UNITED STATES PATENT AND TRADEMARK OFFICE

APPLICATION NO.	FILING DATE	FIRST NAMED INVENTOR	ATTORNEY DOCKET NO.	CONFIRMATION NO.
10/525,430	02/23/2005	Christian Clauss	MCA-615 US	5741
25182	7590	12/20/2007		
MILLIPORE CORPORATION 290 CONCORD ROAD BILLERICA, MA 01821			EXAMINER MENON, KRISHNAN S	
			ART UNIT 1797	PAPER NUMBER
			MAIL DATE 12/20/2007	DELIVERY MODE PAPER

Office Action Summary	Application No. 10/525,430	Applicant(s) CLAUSS, CHRISTIAN	
	Examiner Krishnan S. Menon	Art Unit 1797

DETAILED ACTION

FIG. 5

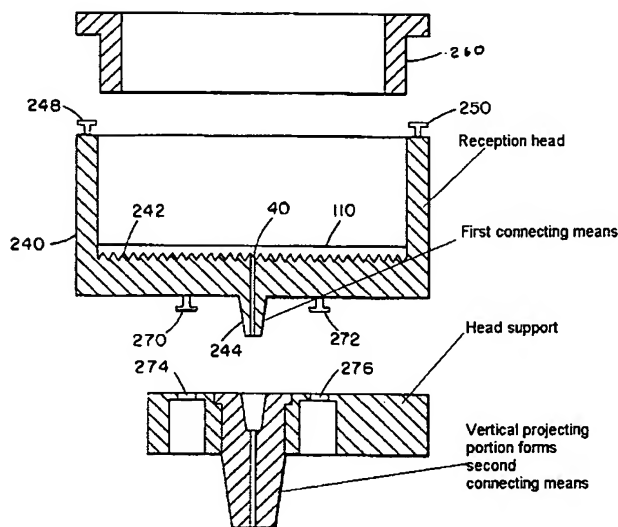
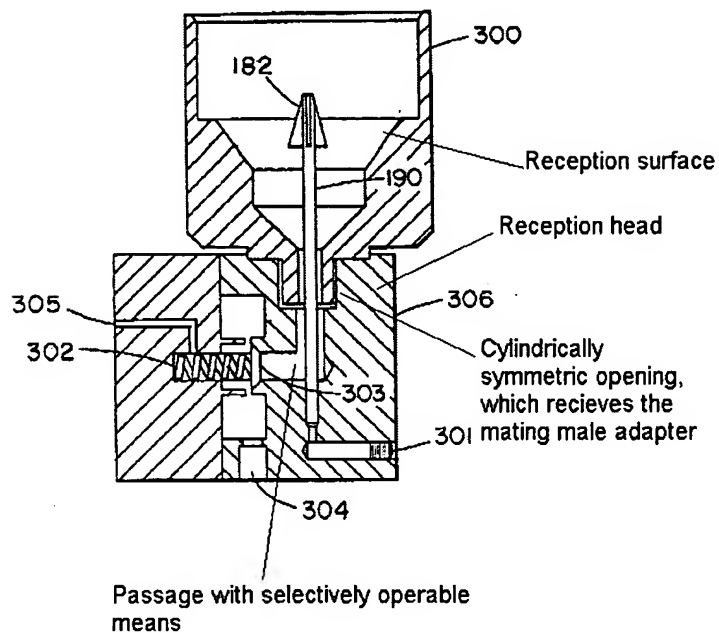
Claims 4-6: figure 5 of Johnson reads on claims 4 – 240 can be the reception head that receives a filter over 242; the mating part below 240 is the head support.

Keying means – 270-274, 272-276. See the figure below:
